## Metro Central Joint Development Assessment Panel Agenda

Meeting Date and Time: Meeting Number: Meeting Venue: 29 May 2017; 10:30am MCJDAP/240 Town of Bassendean 35 Old Perth Road Bassendean

8.1	Property Location:	Lot 25 (No. 300) Collier Road, Bassendean
	Application Details:	Proposed Convenience Store
	Applicant:	Planning Solutions
	Owner:	HICON (WA) PTY LTD
	Responsible authority:	Town of Bassendean
	DoP File No:	DAP/17/01187

Chk RFH	
Drm PARA	
Date DECEMBER 2016	
Scale@ A1 AS SHOWN	CONSULTING
Surv\Scan	39 Woodley Rd Glen Iris WA 61+ 11 439 697946
Approved	Drawing 1616-TP5 c

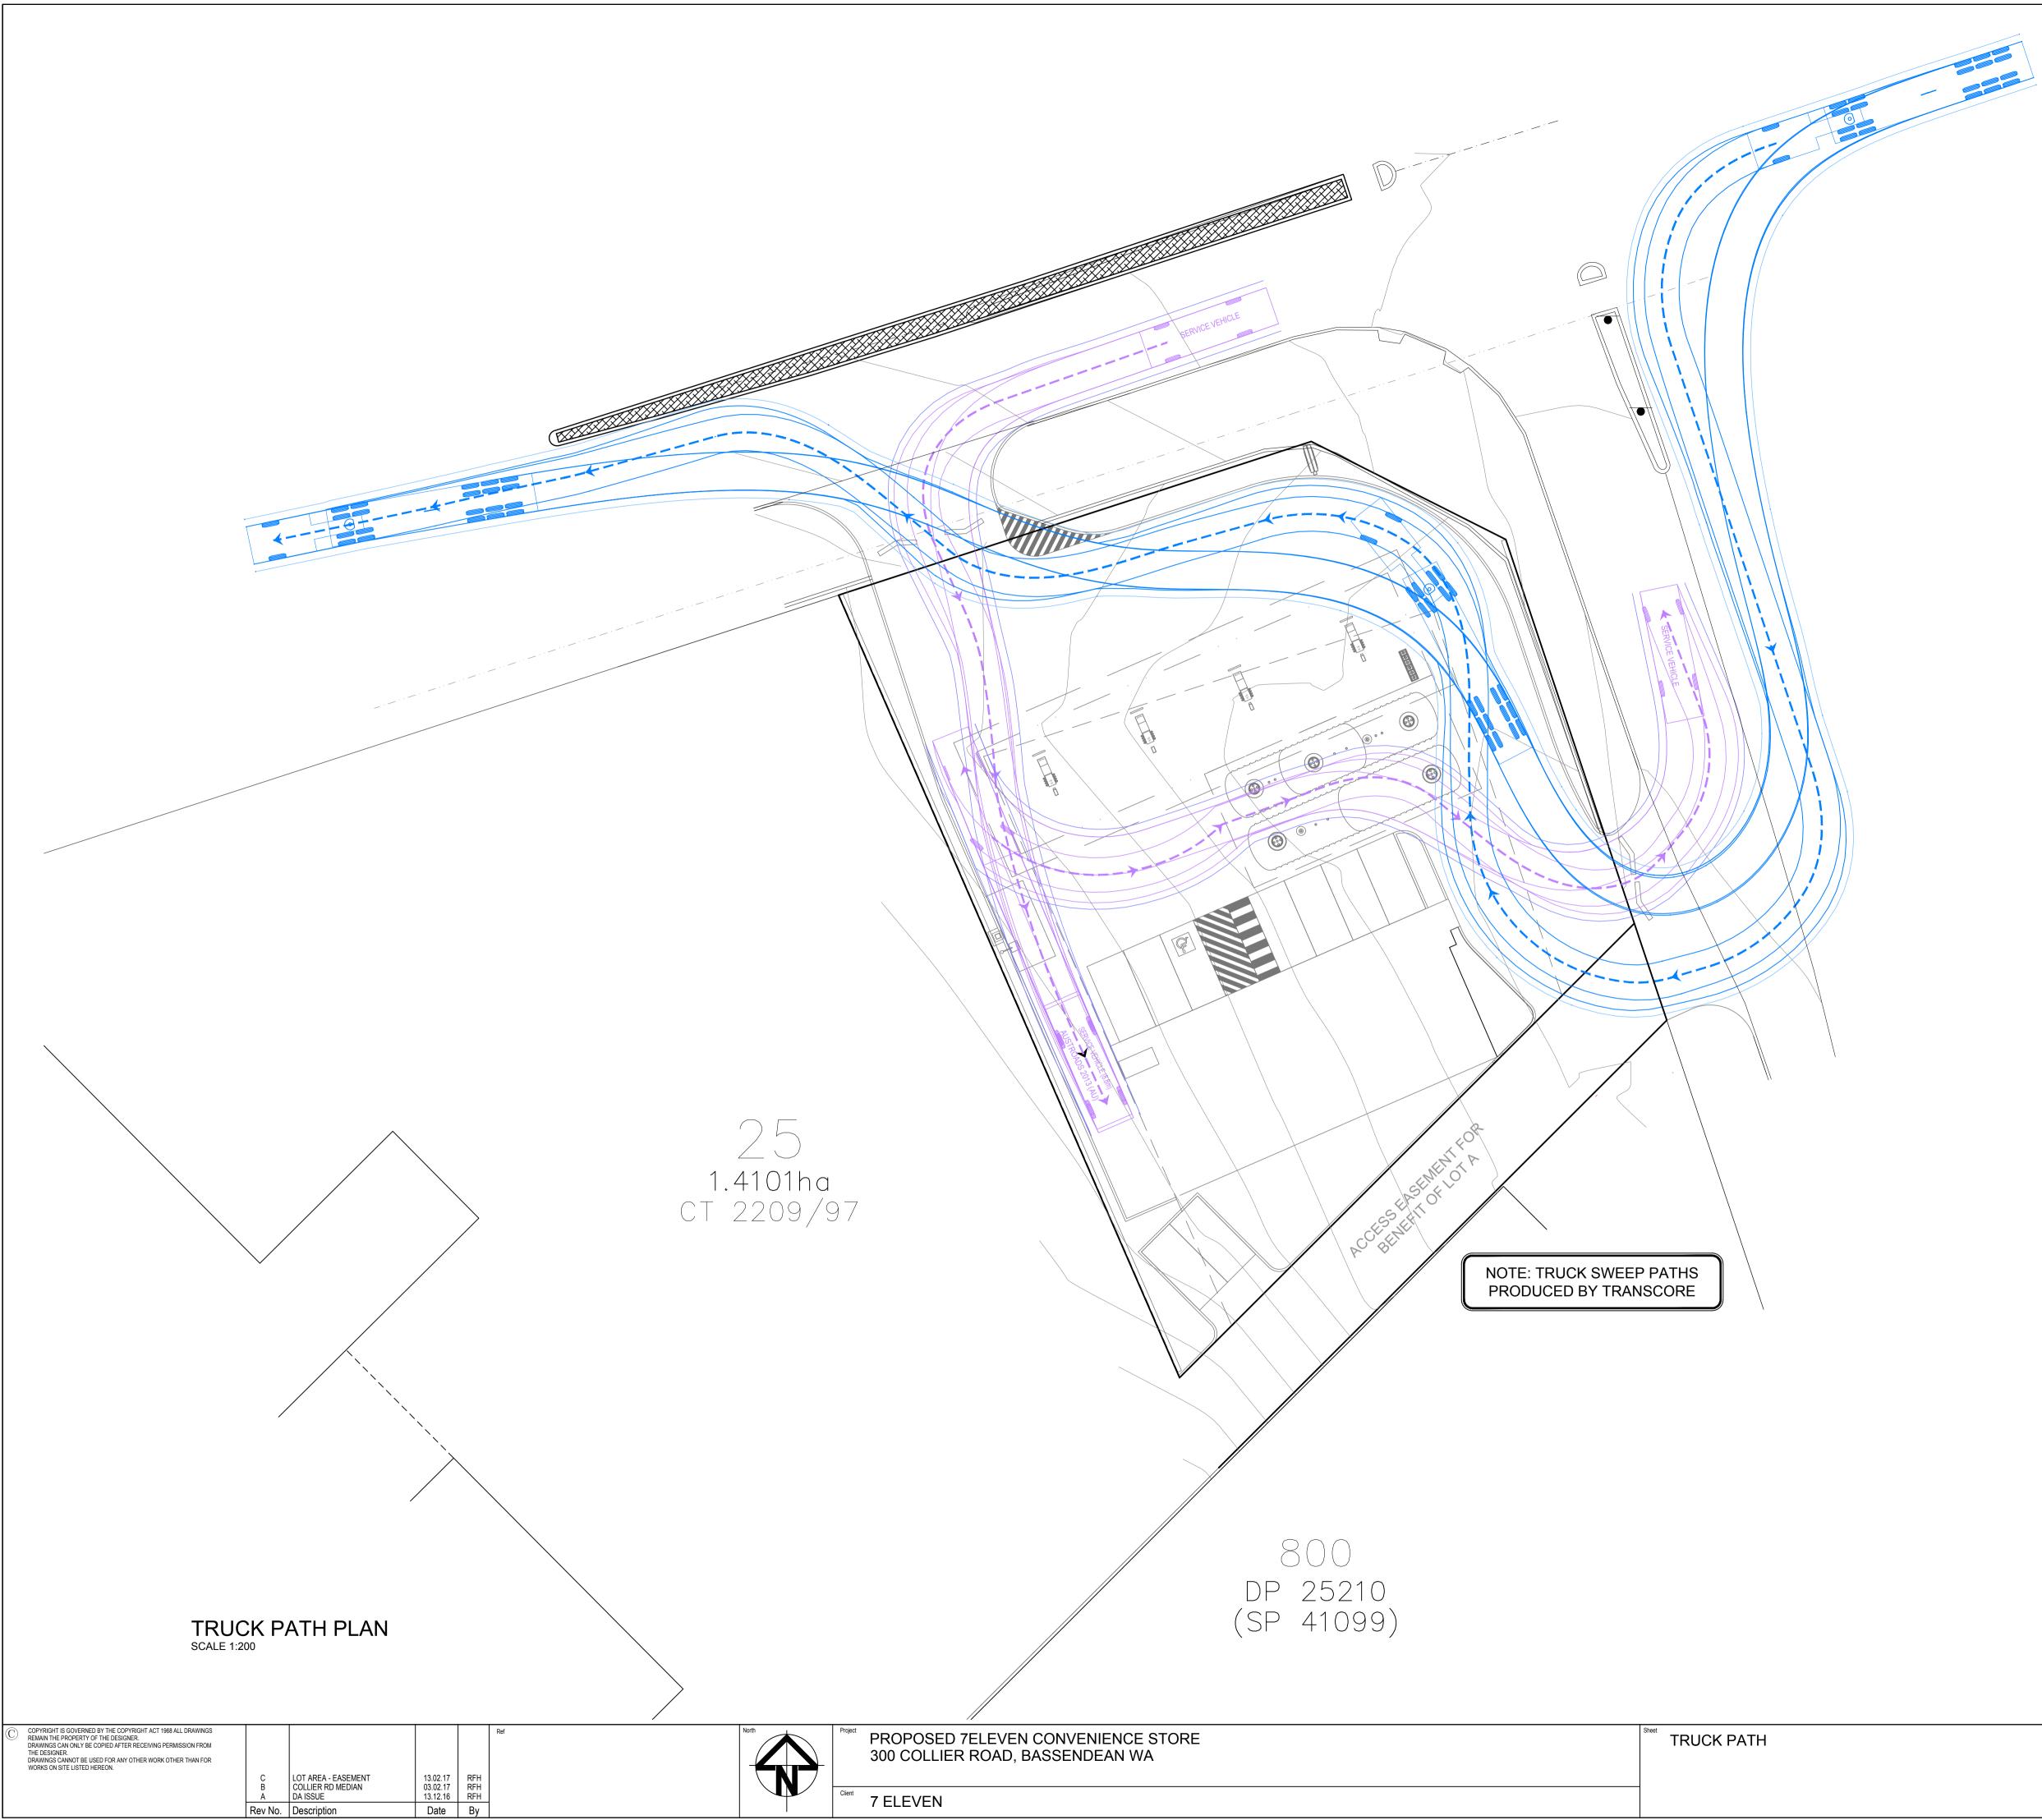
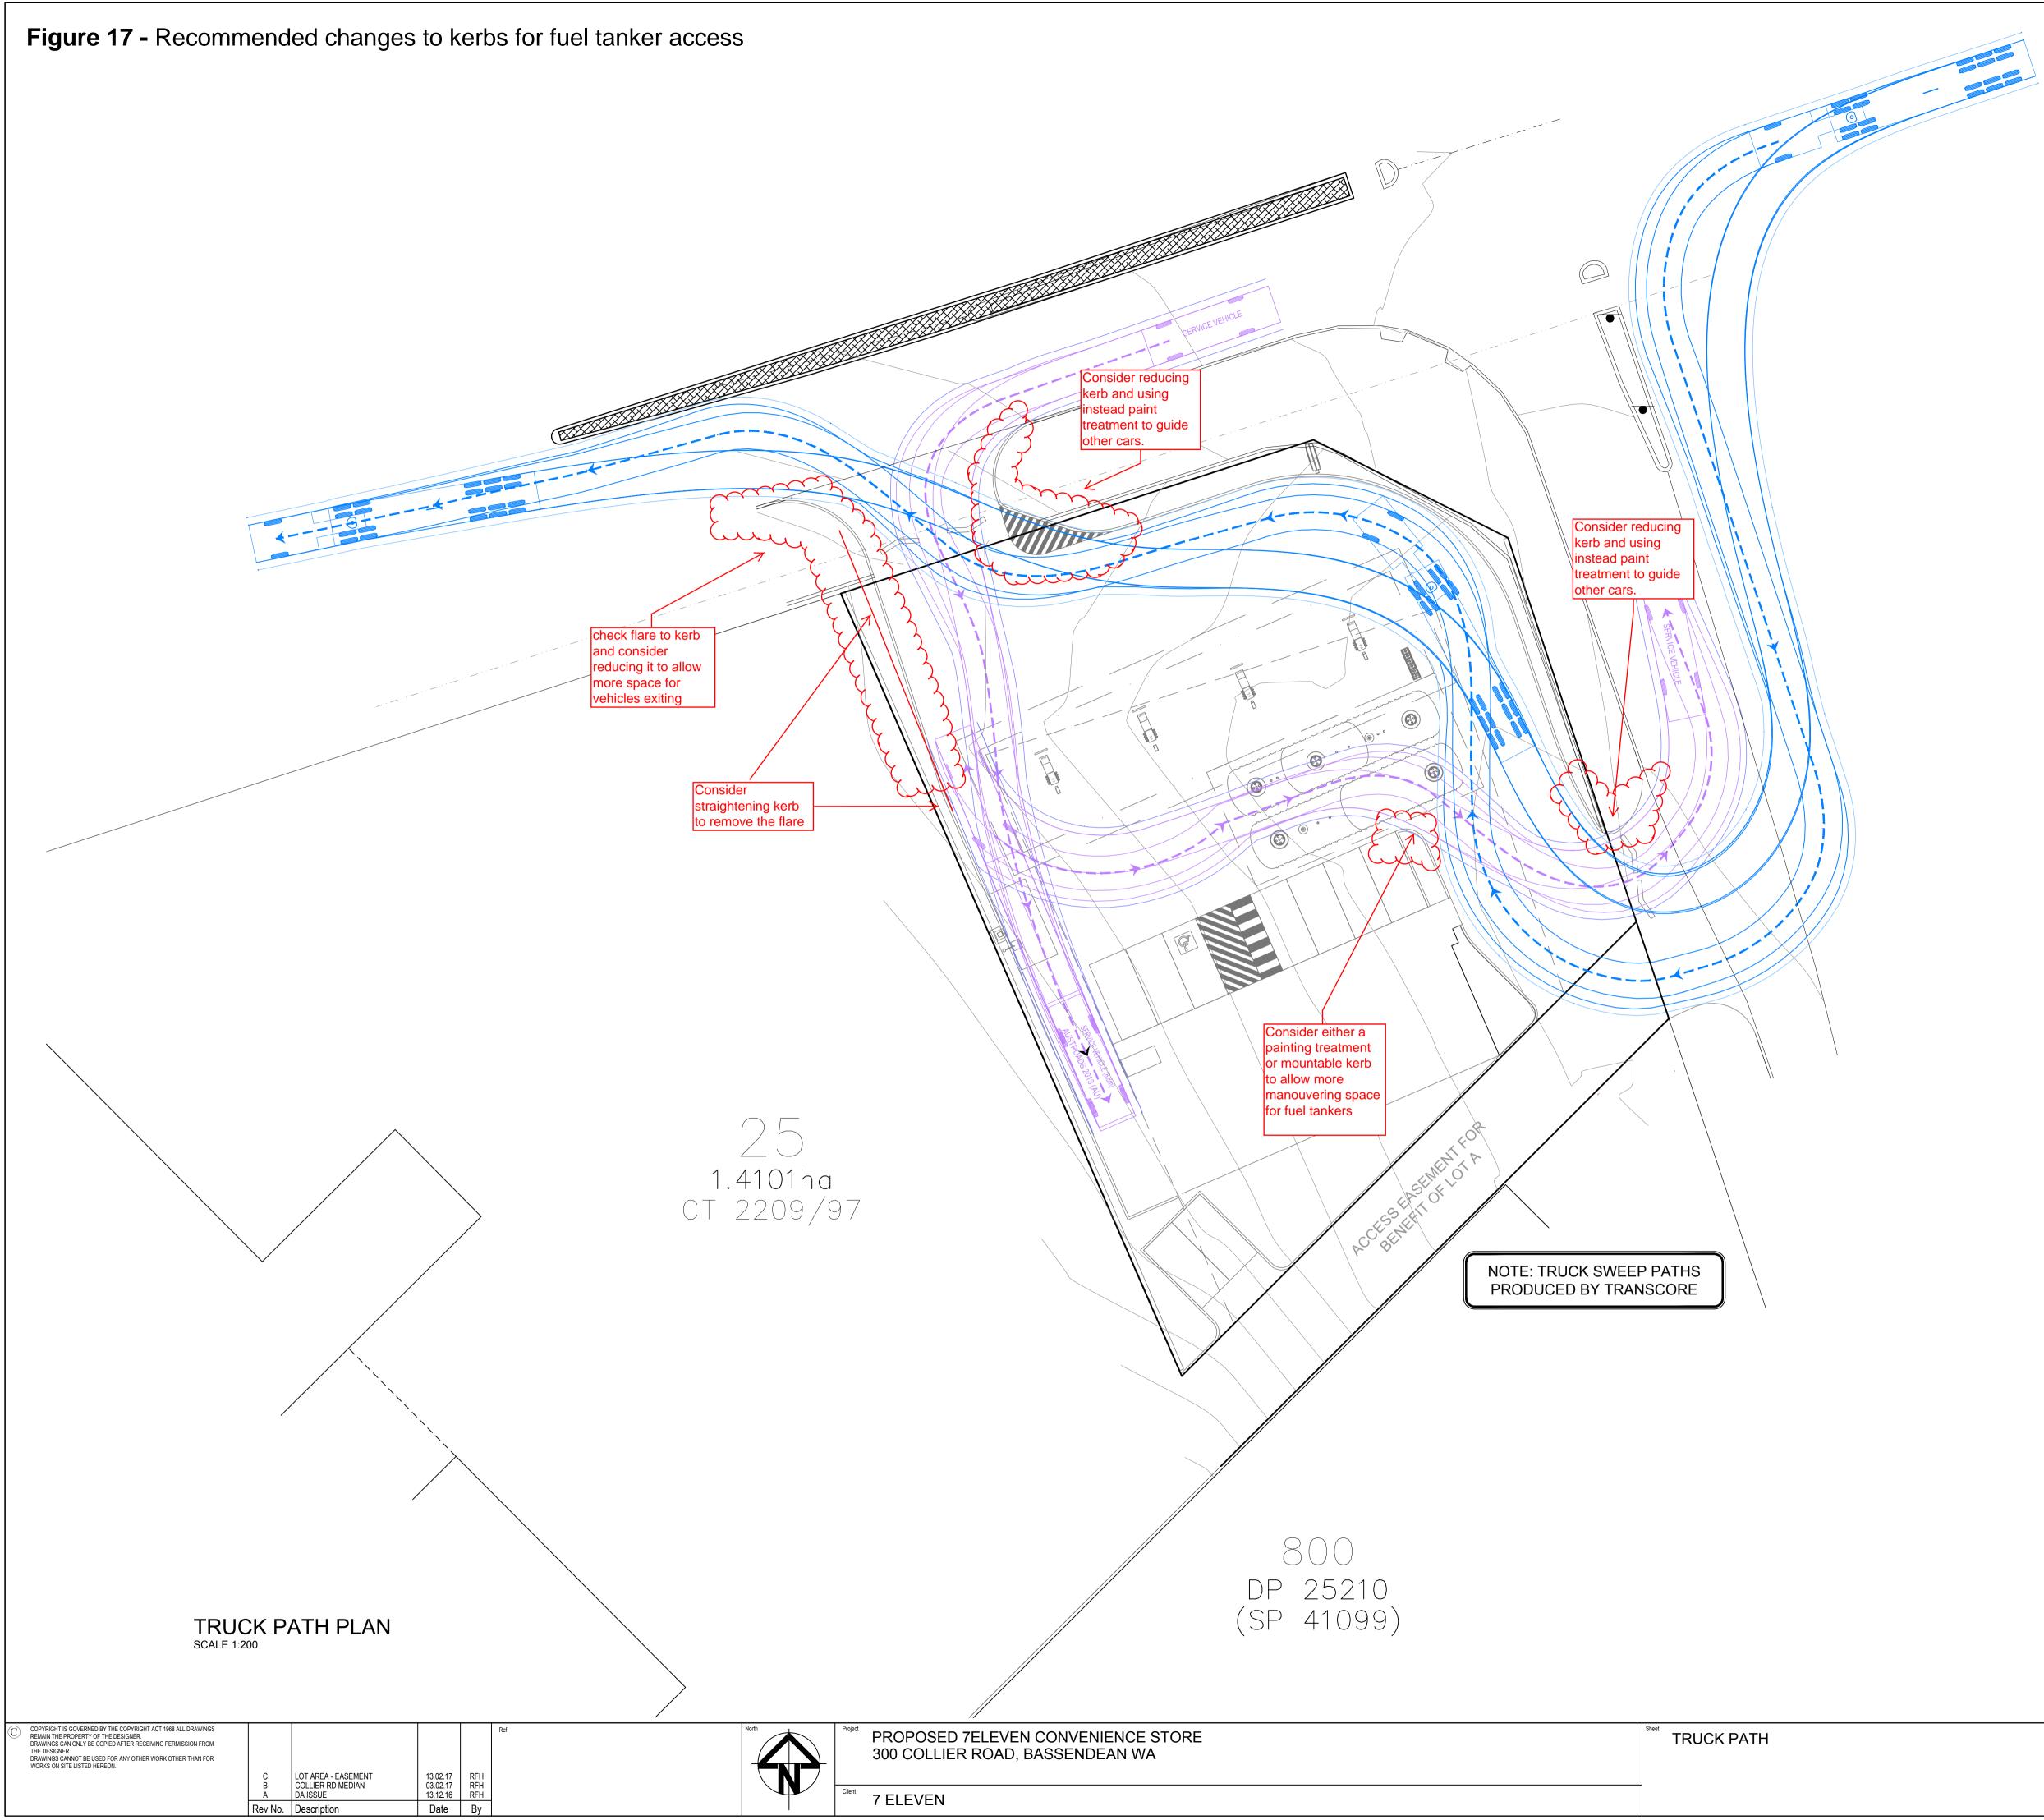
It is understood that the swept paths shown in *Figure 17* are based on the movements of a 19m long fuel tanker. The Department recommends consideration be given to making minor modifications as follows:

#### These recommendations are shown in red on the marked up map shown at Figure 17.

- b. A reduced height to S1 High Main Price Board to a maximum height of 6m.
  - c. Straightening of the kerb on the western side of the site to increase the width of the proposed crossover as shown in red on drawing titled Figure 17. The crossover wing radius must be a minimum of 5.0m in accordance with the Towns crossover specifications.

# Figure 4 - Site Plan

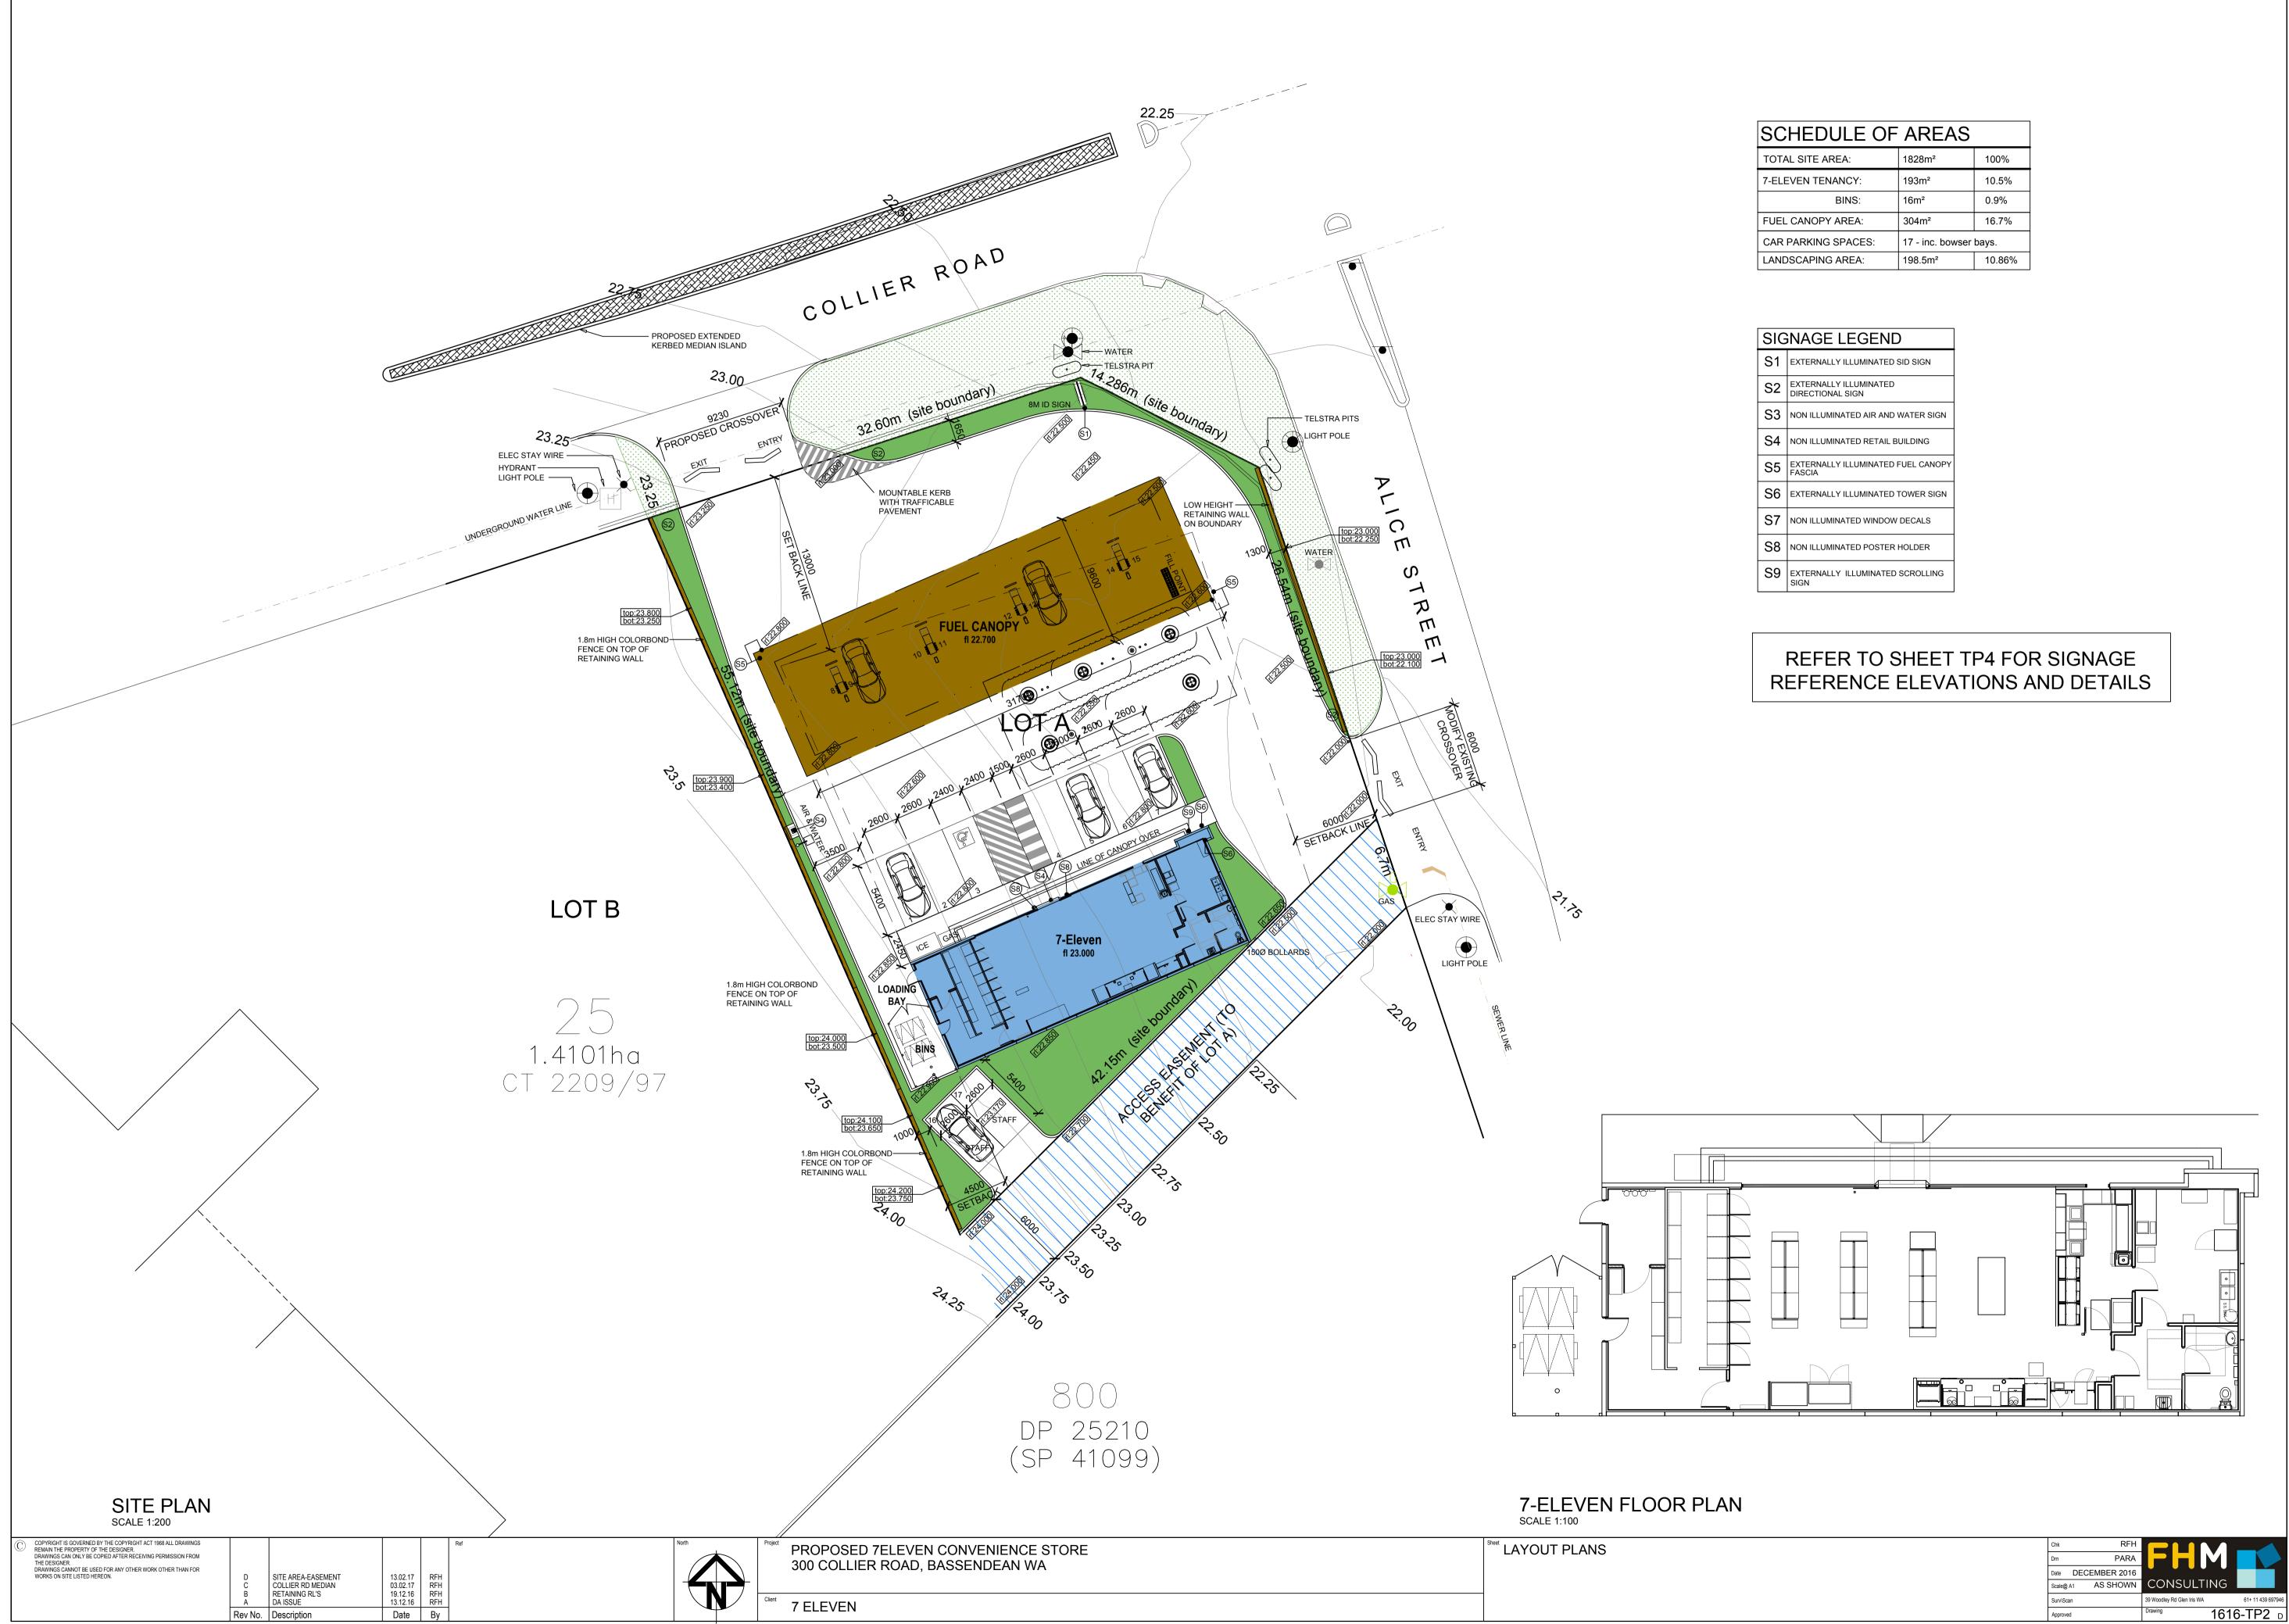
The TIA refers to the site plan shown at *Figure 4* as evidence of this, however the site plan does not show any footpaths. It is therefore recommended that any future iterations of the TIA be updated to correct for this omission.
